MEETING AGENDA

Planning and Zoning Commission

MEMORANDUM

Topic: Case 25-07: Site Plan Review for Tequila Raizes Restaurant, 18136 Dixie Highway

PROPOSED SITE PLAN
NOT TO SCALE

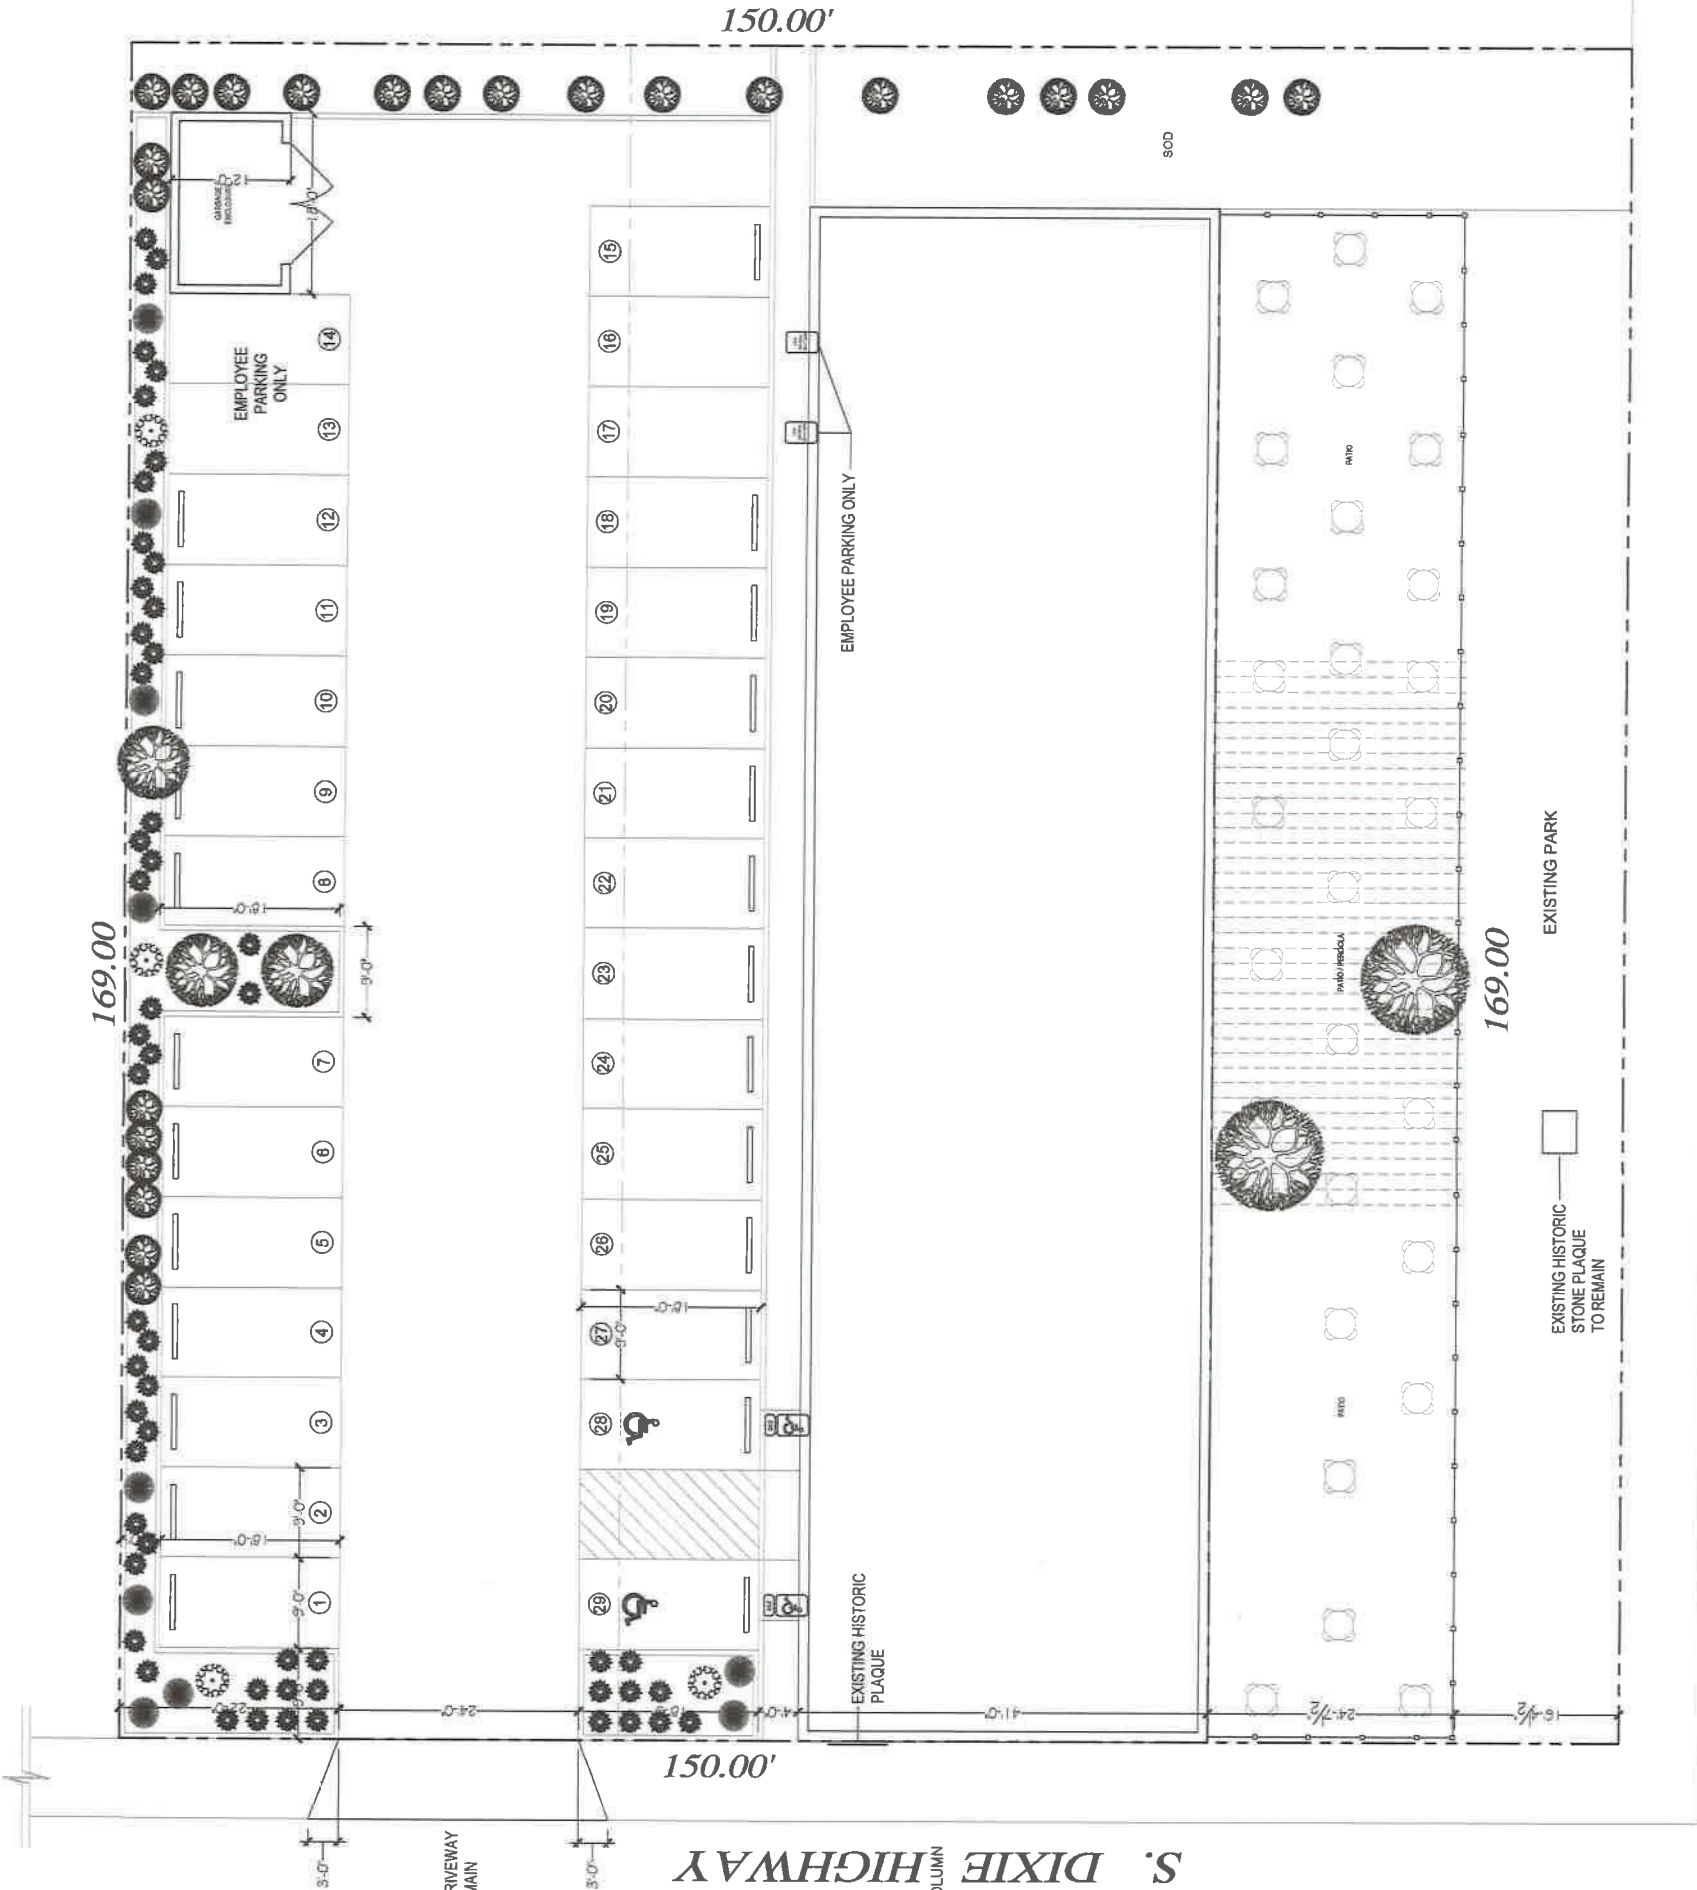
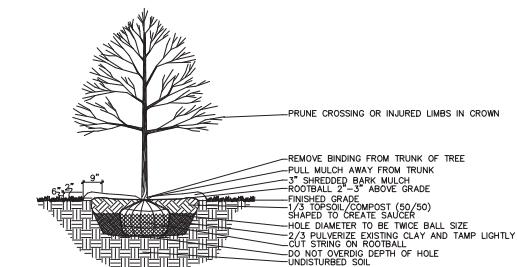
The Zoning Ordinance requires new parking areas with greater than 30 parking spaces to provide interior parking lot landscaping, including landscape islands, landscape "end caps," and additional screening. These additions would reduce parking by up to 5 parking spaces on-site. A variance would also be required to meet parking requirements. An administrative exception will avoid additional loss of off-street parking on the site and mitigate the need for additional variances. This site is also adjacent to a large public parking lot located across Hickory Road; this lot is determined by the Village's downtown parking study to have available parking capacity at the anticipated peak hours of the restaurant business.

The parking lot will be designed with two rows of parking along a single aisle on the south side of the building. The aisle will feature a single driveway onto Dixie Highway. The drive aisle in the parking lot will be 24 feet wide to support two-way traffic. An unmarked area near the back of the parking lot has been set aside for vehicles to turn around without blocking other vehicles. Landscaping along the southern property boundary, adjacent to Abundant Grace UCC, will screen the parking area, including six existing canopy trees that will remain. A trash enclosure will be placed at the rear of the parking lot. A 10-foot buffer is planned between the parking lot and the rear property boundary to protect existing trees and a utility easement.

The applicant has proposed the construction of a new parking area with 29 parking spaces. No new interior parking lot landscaping (including parking lot landscape islands and “end caps”) is required. The applicant has proposed one (1) parking lot landscape island to improve the aesthetic quality of the parking area, which will include two small trees and a variety of shrubs and grasses.

At the August 7 meeting of the Appearance Commission, the Commission conditioned approval of the Appearance Review for this project on the relocation of this parking lot landscape island from its current location to a new location immediately to the east of the proposed trash enclosure. This relocation will improve screening for the proposed trash enclosure. A new parking space is required to replace the current location of the parking lot landscape island. See *Appearance Commission Decision*.

3. **Parking Island:** Move the existing parking island to a location adjacent to the trash enclosure to provide screening for the enclosure, which meets Zoning Ordinance requirements (Section 44-08). *Staff recommends that Appearance Commission approval be conditioned upon the movement of the parking island, the parking space closest to the proposed enclosure.*

1. **Appearance Commission Conditions:** Apply all conditions approved by the Appearance Commission at the Appearance Review hearing for this proposal on August 7, 2025, and revise all drawings to incorporate conditions before the issuance of building permits.
2. **Landscape Materials:** Replace landscape materials as agreed to with the Village Arborist, including the following recommended replacements (as appropriate):

PROPOSED
LANDSCAPE PLAN

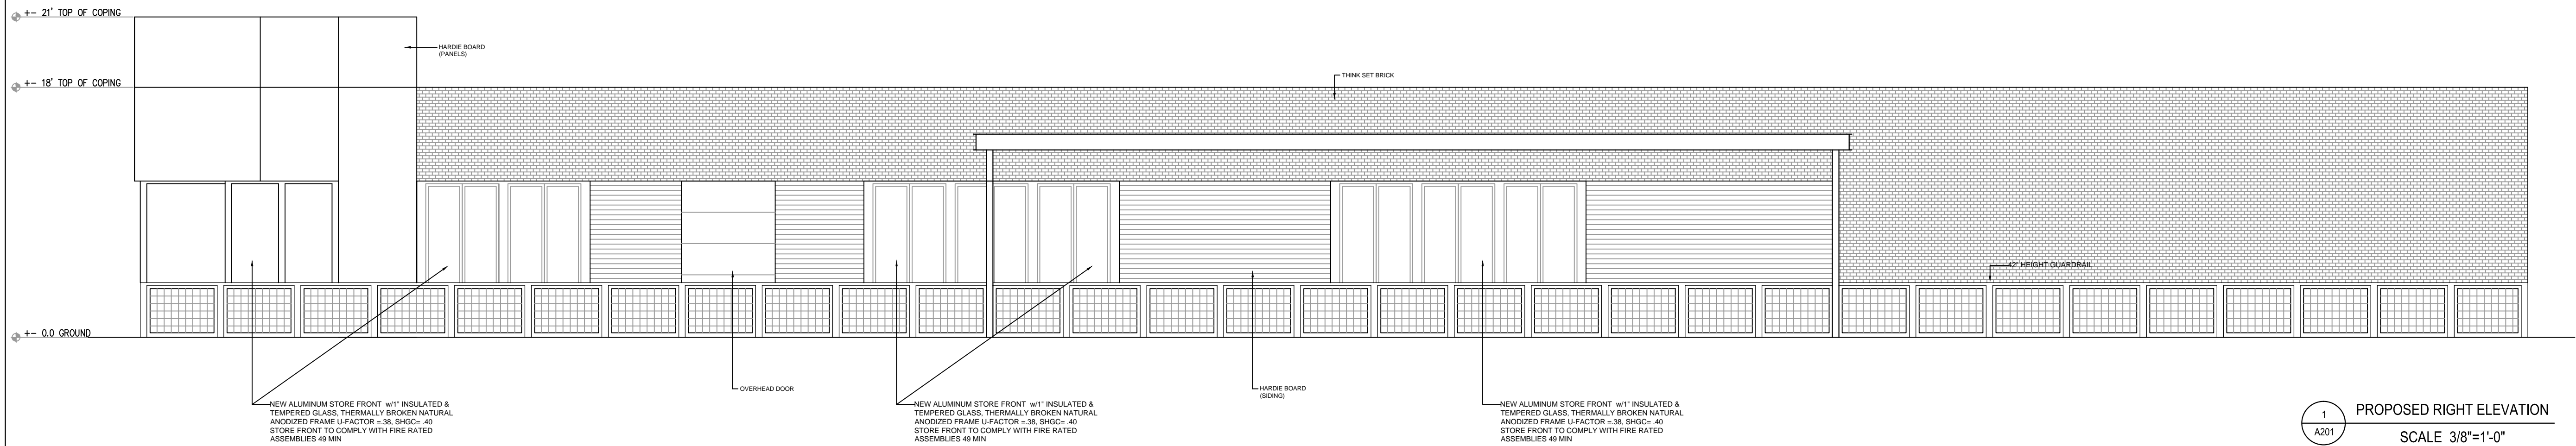
The Village Arborist has reviewed all landscape plans and recommended replacement of the proposed plant palette with the following materials:

- *Canopy Trees:* Silver linden, zelkova
- *Shrubs/Understory Trees:* Japanese tree lilac, dwarf vibranum
- *Groundcover:* Little bluestem

4. **Landscaping Materials:** Replace landscape materials as agreed to with the Village Arborist, including the following recommended replacements (as appropriate):

- a. Silver linden
 - b. Zelkova
 - c. New elm species
 - d. Japanese tree lilac
 - e. Fragrant dwarf vibranum or diervilla
5. **Green Panels on South (Side) Elevation:** Add two green panels and shift all panels approximately 20-30' toward Dixie Highway to add façade articulation closer to Dixie Highway where the building is visible from the public right-of-way.

- a. Silver linden
 - b. Zelkova
 - c. New elm species
 - d. Japanese tree lilac
 - e. Fragrant dwarf vibranum or diervilla
3. **Lighting Plan:** Submit a comprehensive lighting plan to Village staff for review, including a photometric plan and product cut sheets. Staff will review the lighting plan for compliance with the Zoning Ordinance and other Village codes and ordinances.

1
A201
PROPOSED FRONT ELEVATION
SCALE 3/8"=1'-0"

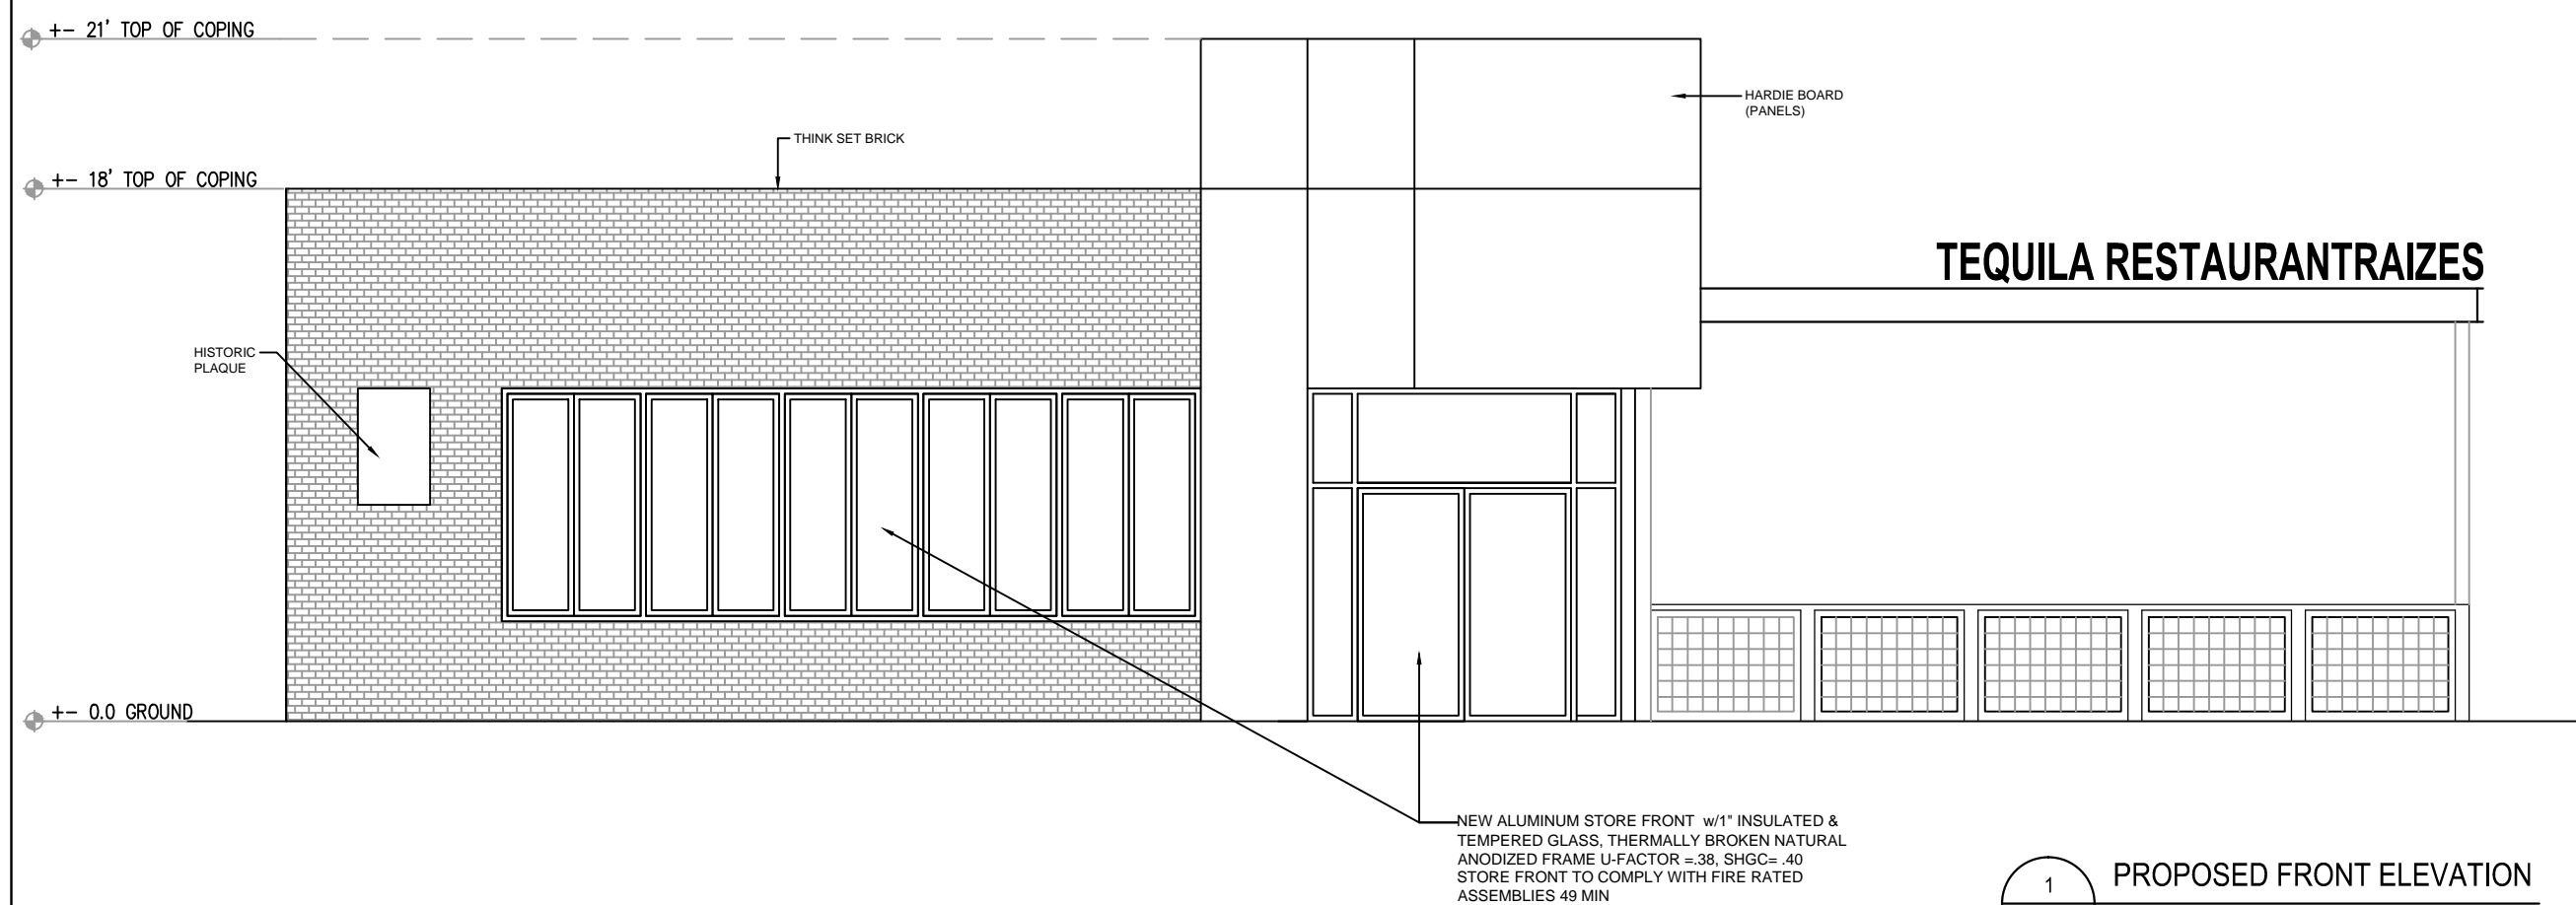
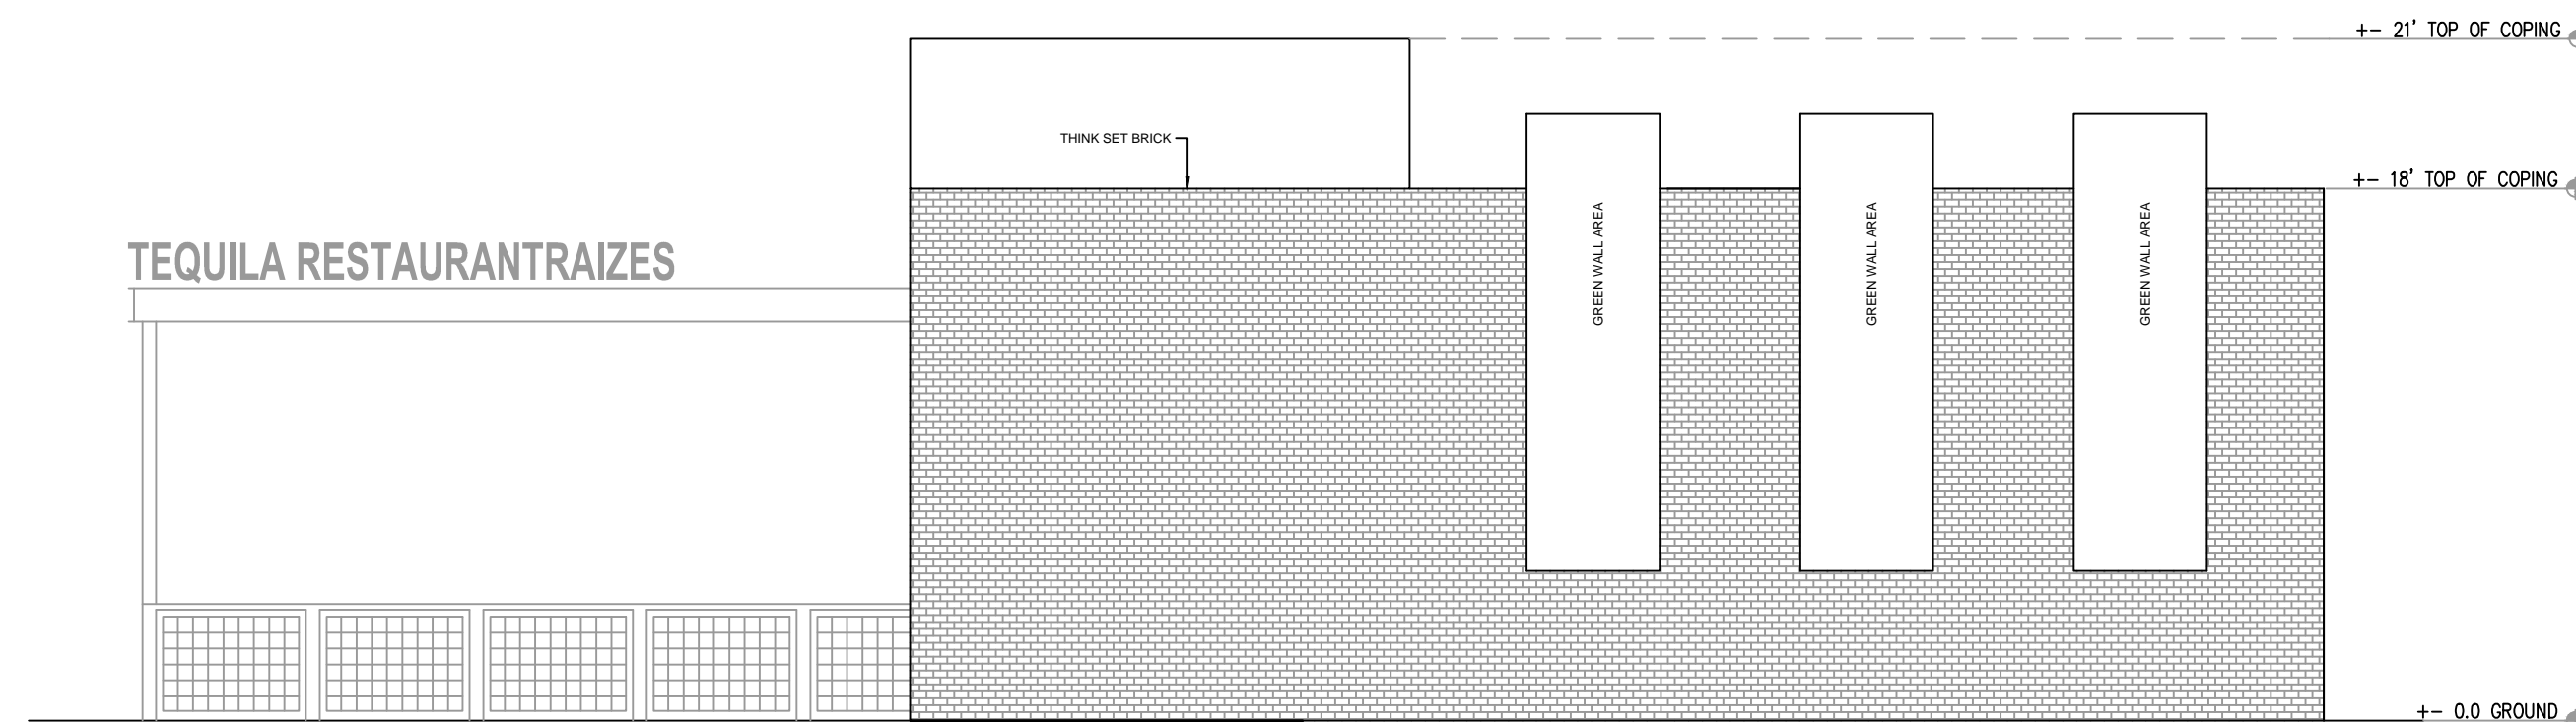
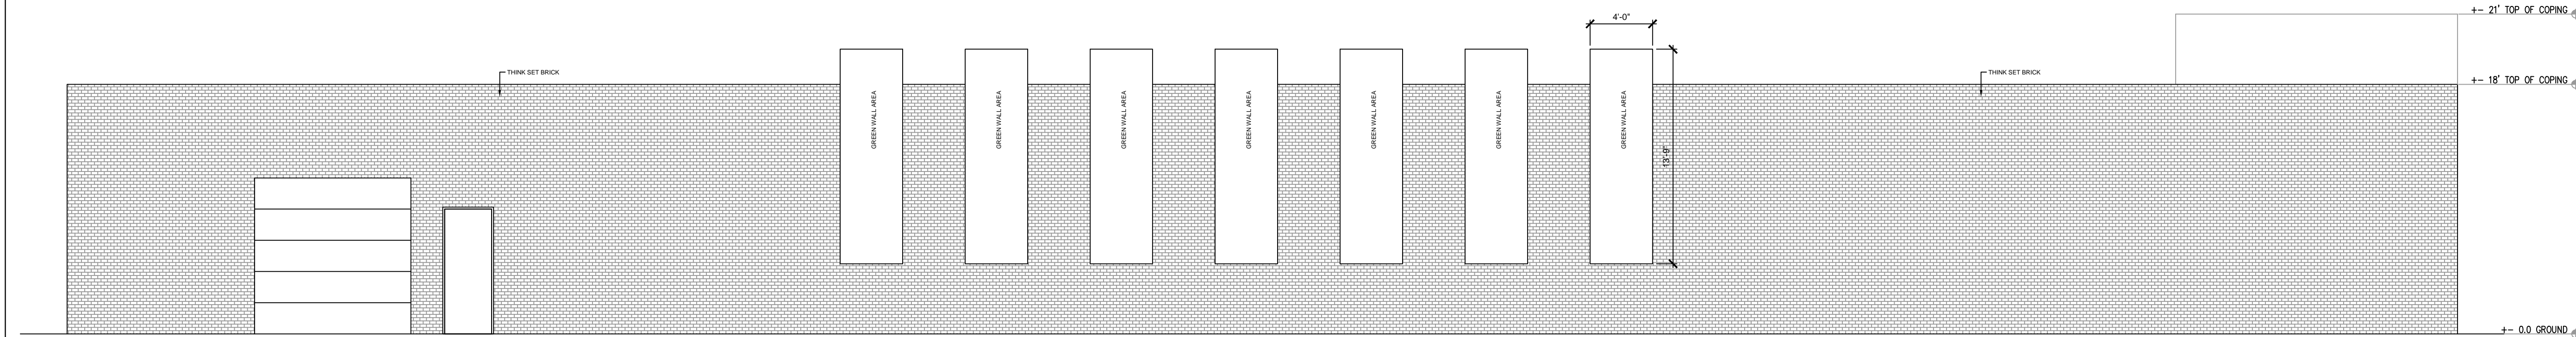
On August 7, the Appearance Commission conditions Appearance Review approval for this project on a replacement of the black brick color for the building, which was deemed to be incompatible with surrounding community character. The Commission recommended replacement of the black brick color with a “softened” color such as charcoal gray or dark brown. The applicant will review proposed changes with Village staff and the Appearance Commission for compliance. See Appearance Commission Decision.

On August 7, the Appearance Commission approved the proposed plans for the front elevation along Dixie Highway with reduced transparency requirements. See Appearance Commission Decision.

On August 7, the Appearance Commission requested the addition of 1-2 "green wall" panels along the south elevation. The Commission also recommended the removal of "green wall" panels along the west elevation and the replacement of these panels on the north or south elevation, where plant materials are more likely to survive and panels will be more visible to the public. See Appearance Commission Decision.

- 1. Transparency Requirements:** Reduce transparency standards on the east (front, along Dixie Highway) elevation to accommodate folding windows that are positioned at least 42 inches above the ground.

6. **Green Panels on West (Rear) Elevation:** Remove three green panels and move to blank wall area on north (exterior side) elevation, near the northwest corner of the proposed building.

7. **Brick Color:** Change proposed color of smooth-face brick material from black to a warmer tone compatible with surrounding buildings along Dixie Highway. Recommended to replace color with dark brown brick similar to that used on Homewood Brewing Company (18225 Dixie Highway) and neighboring condominium buildings (18133 Martin Avenue), or another color as recommended by the Appearance Commission.
